Dean Moor Solar Farm

Environmental Statement: Appendix 7.8 – Arboricultural Impact Assessment

Deadline: 2

Revision: ~~21~~

Appendix B Tree Constraints Plan

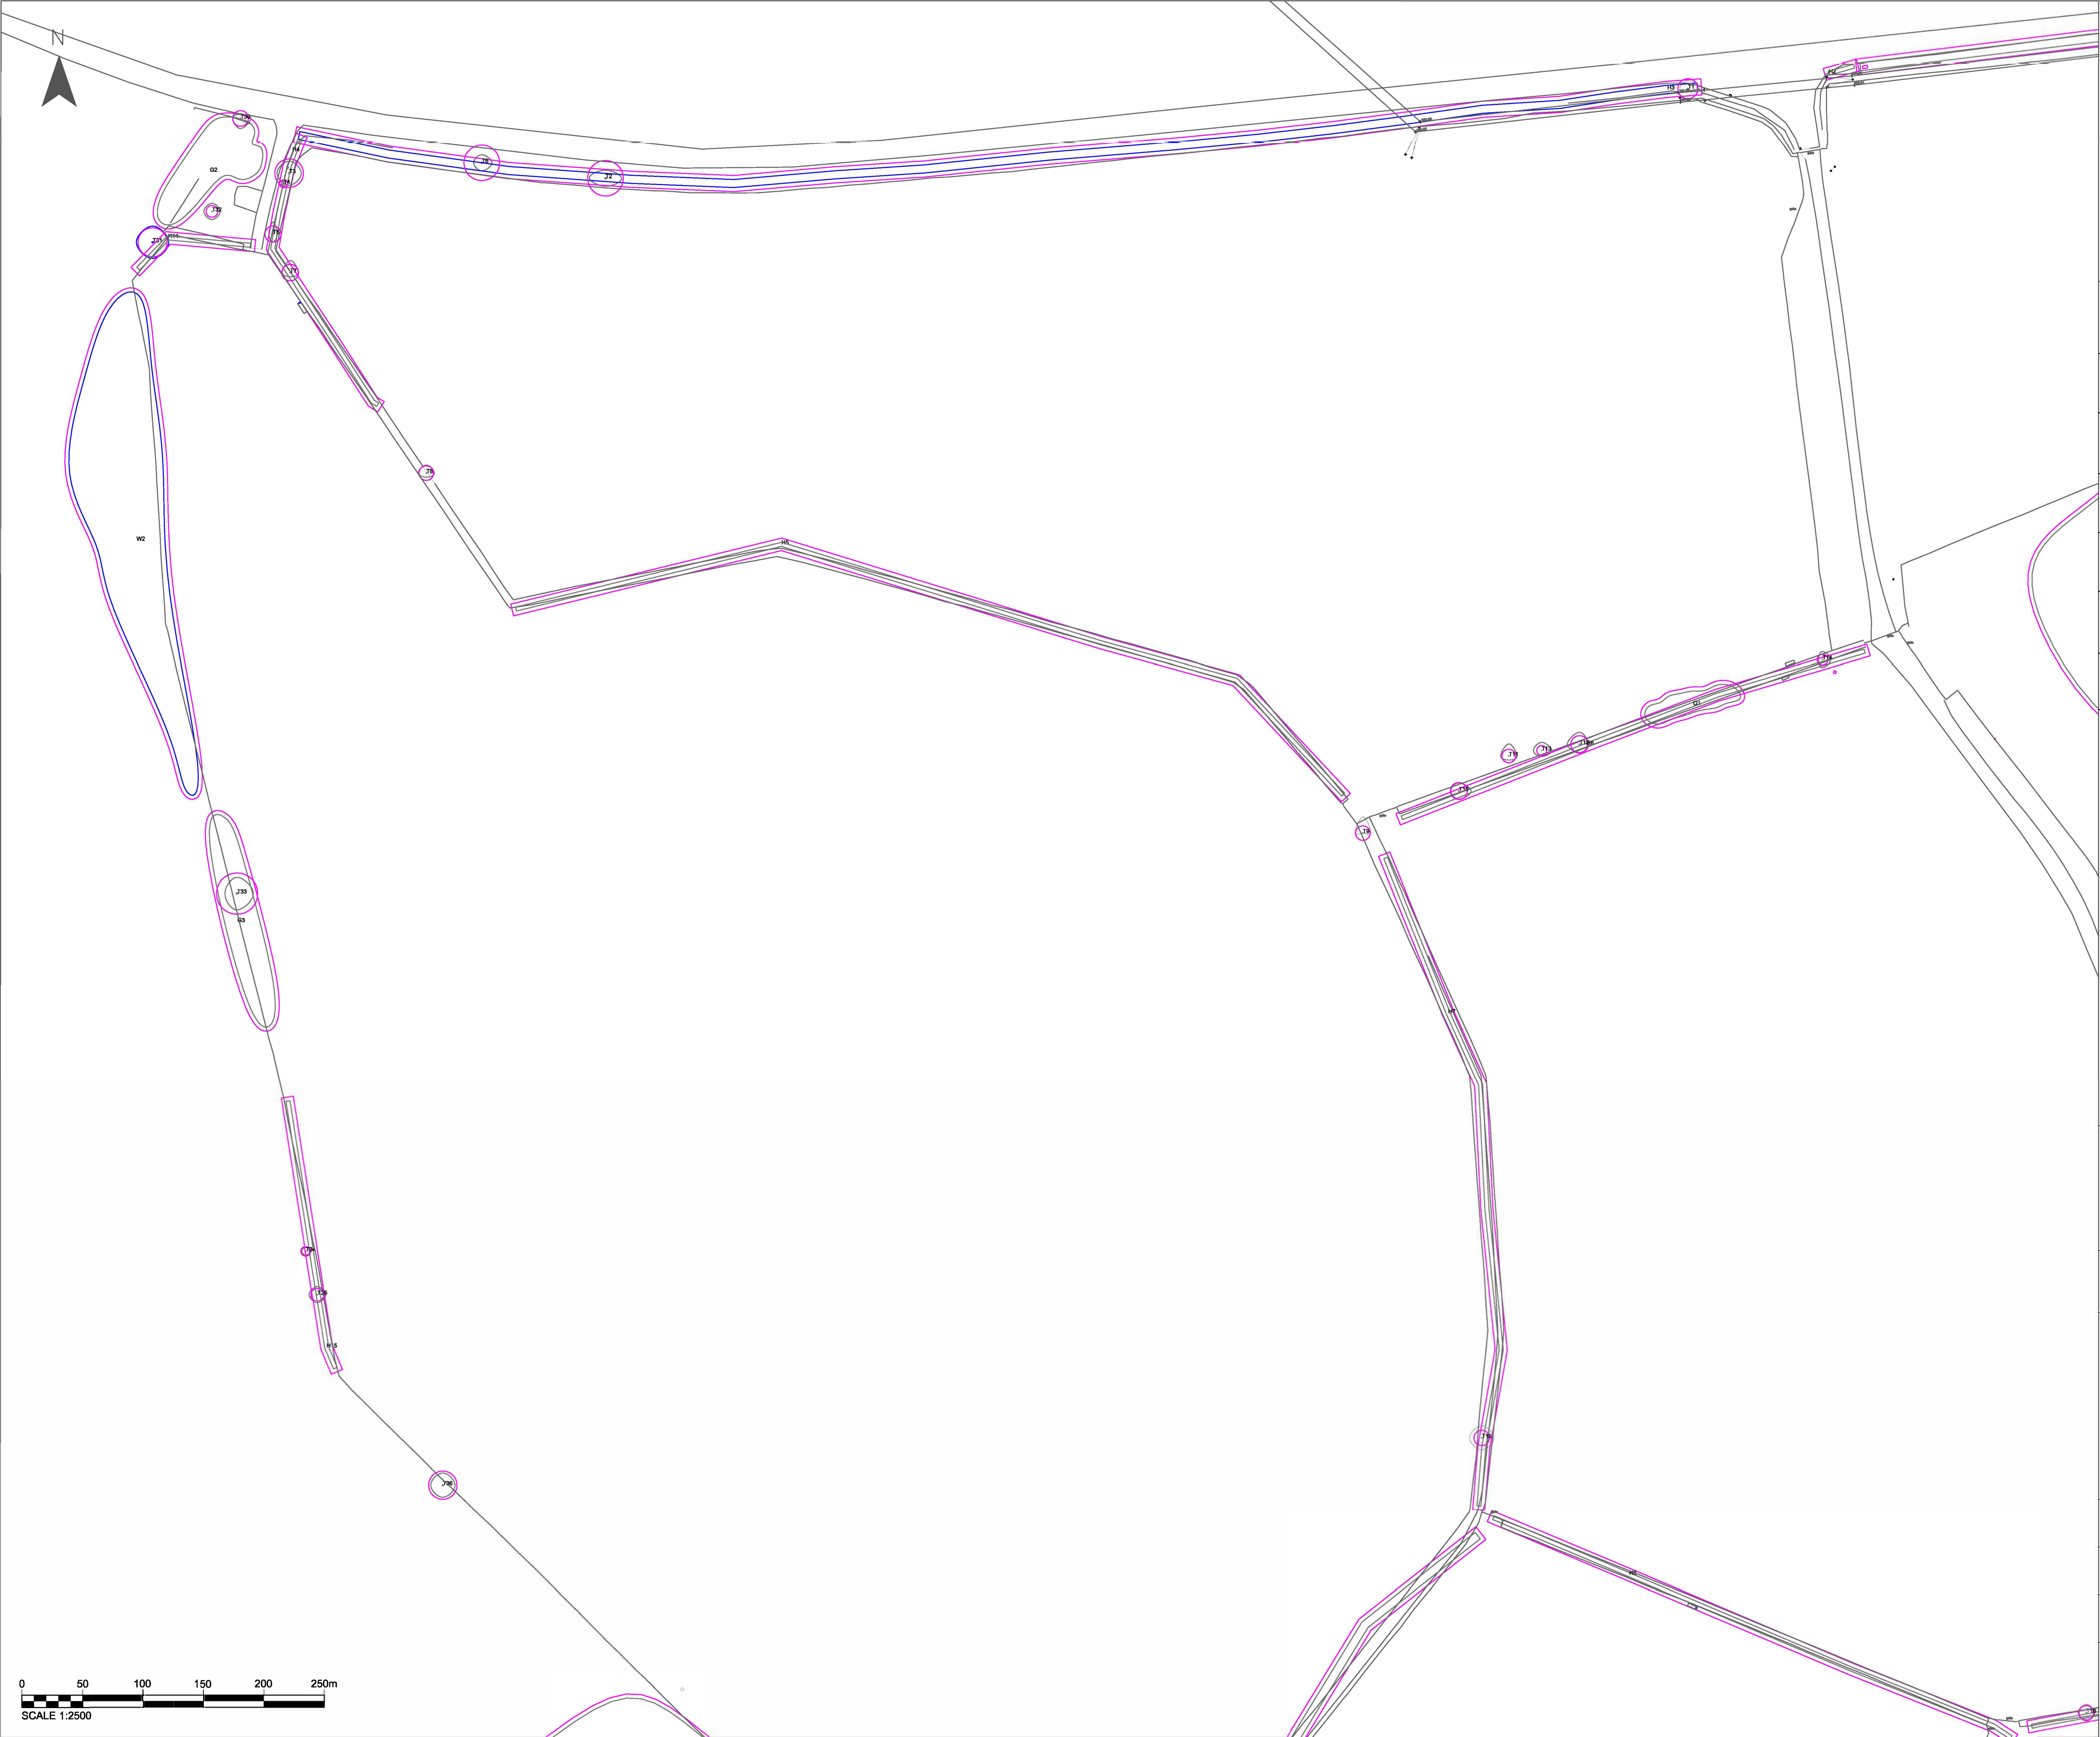
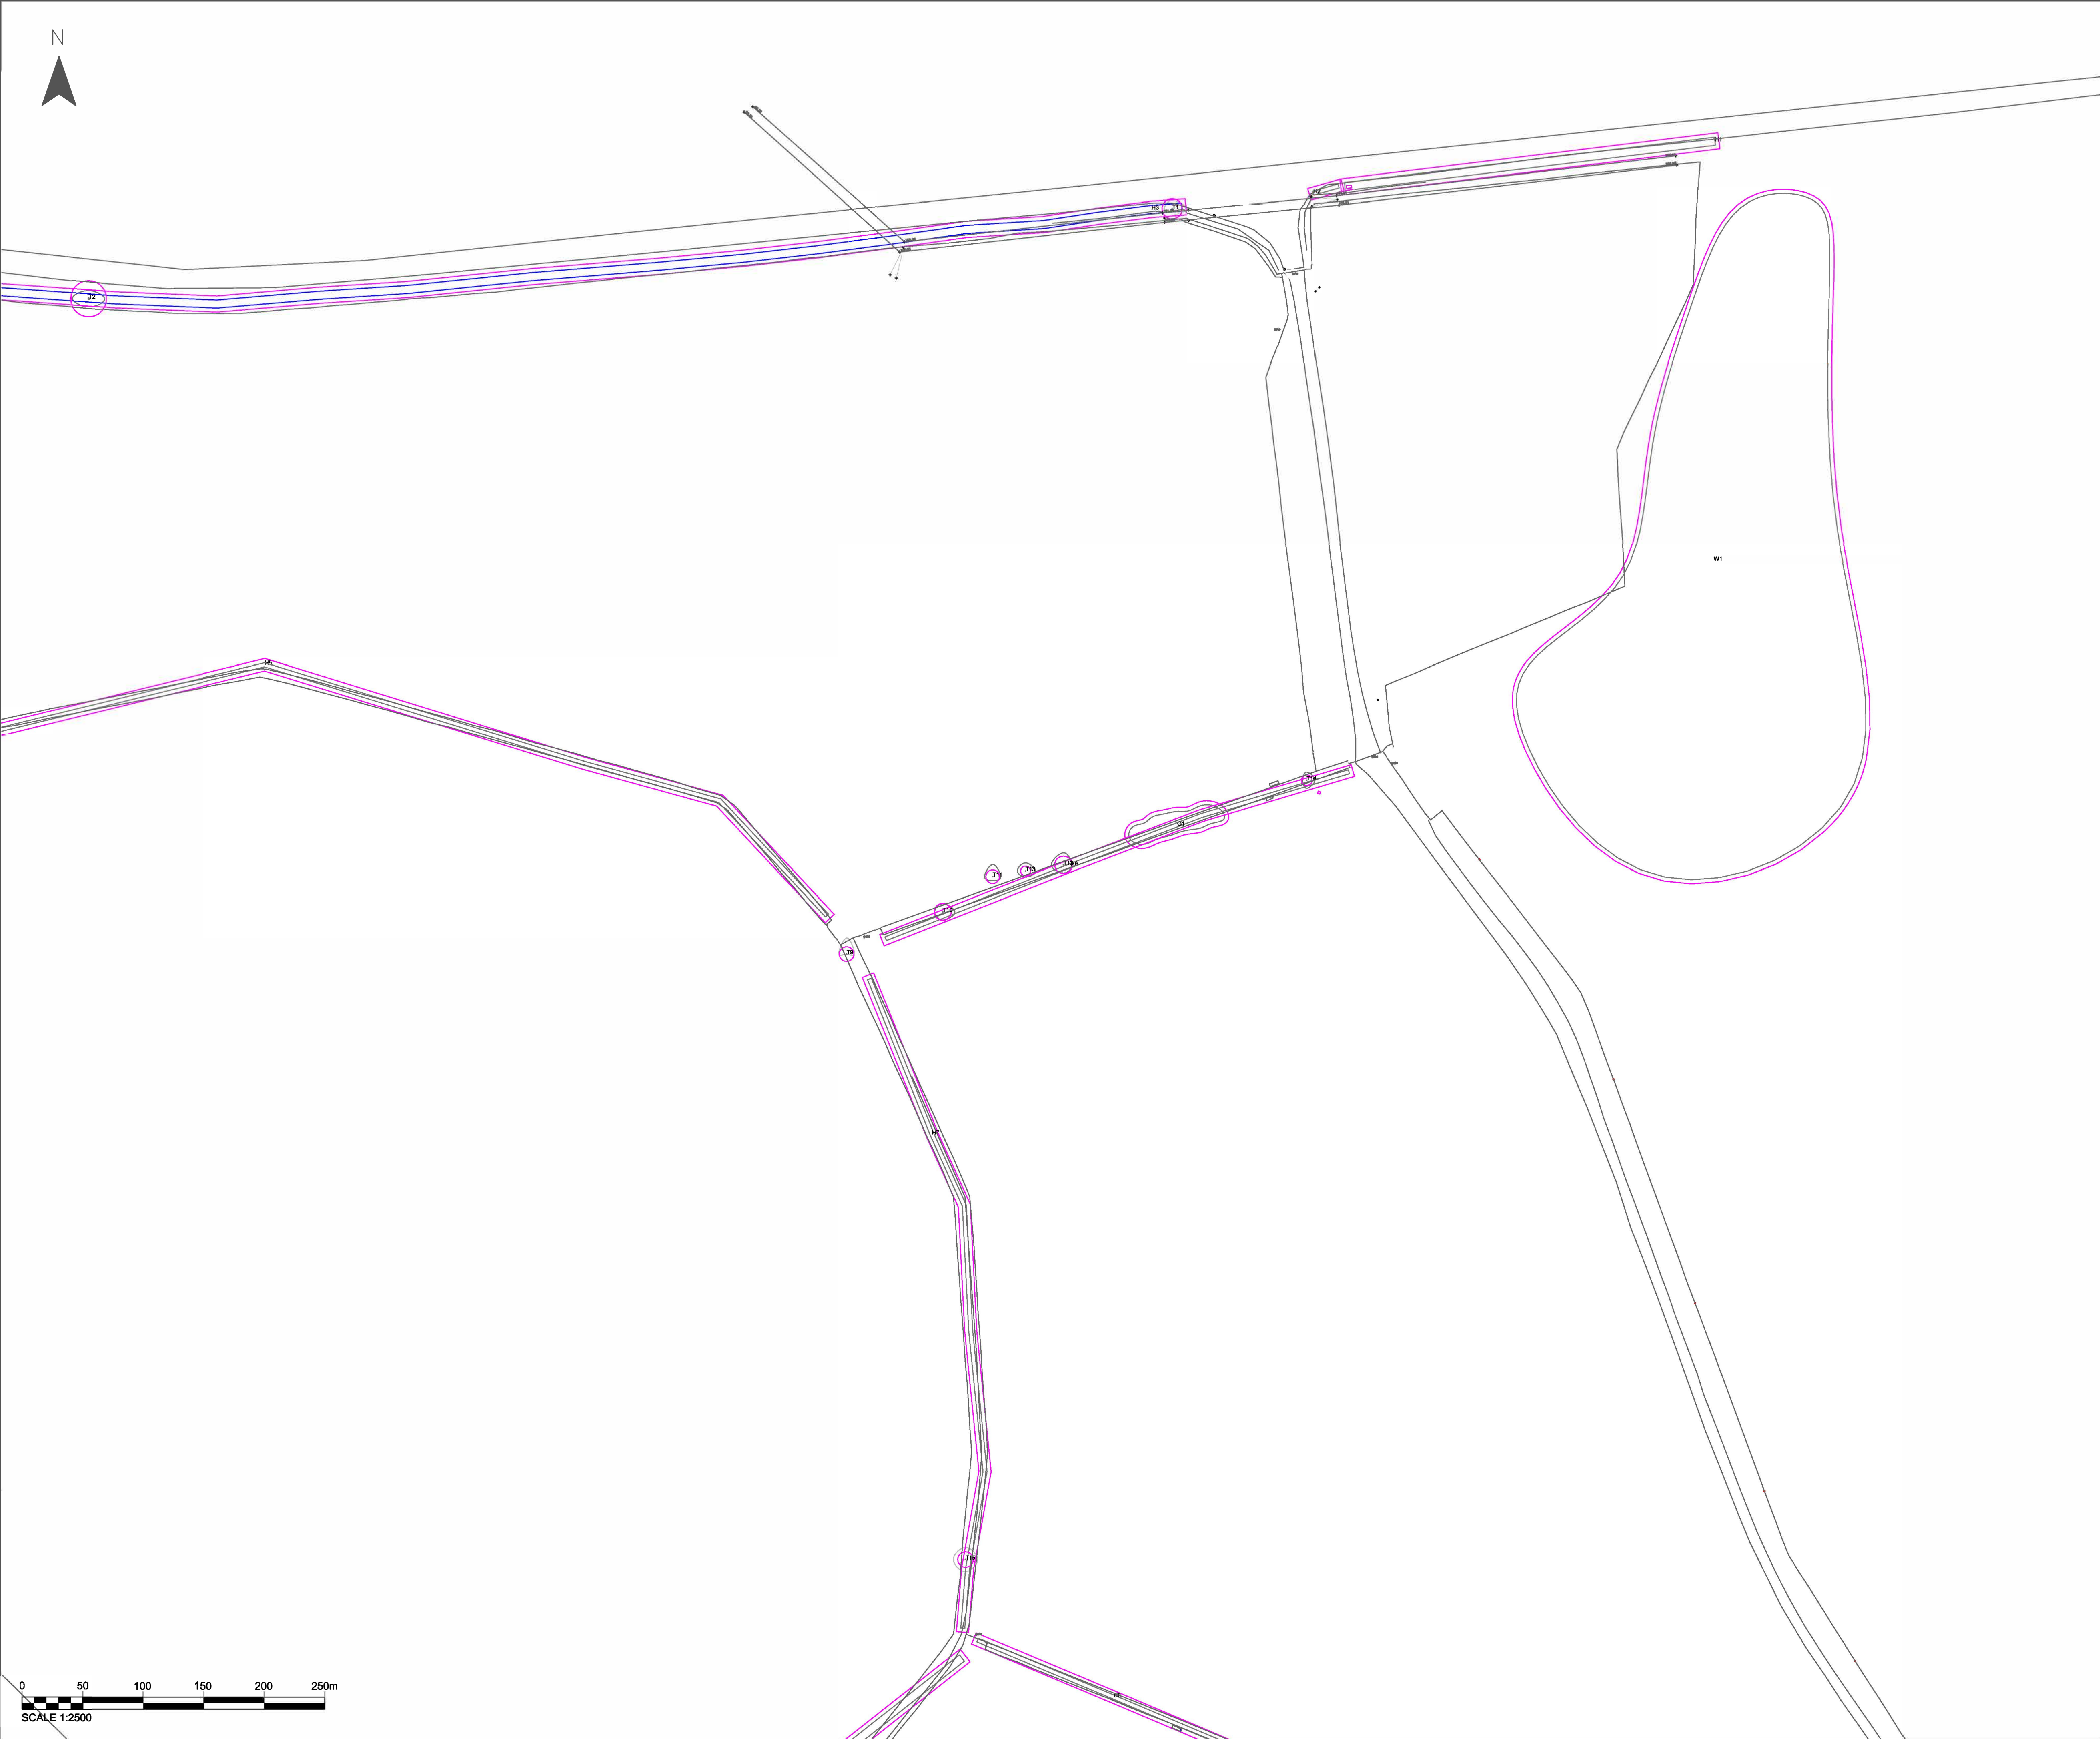
Revision	Reason
Change of the plan title in the TCP from 'Location Plan' to 'Tree Constraints Plan'	To make it clear that the plan is displaying the TCP. As the Location Plan is a different figure within the ES.
A renumbering of the sheets included in the TCP. Changing the order from 0-22 to 1-23.	To enable the first sheet within the TCP is numbered 1 rather than 0.
Change of the plan title in the TPP from 'Location Plan' to 'Tree Protection Plan'	To make it clear that the plan is displaying the TPP. As the Location Plan is a different figure within the ES.
A renumbering of the sheets included in the TPP. Changing the order from 0-22 to 1-23.	To enable the first sheet within the TPP is numbered 1 rather than 0.
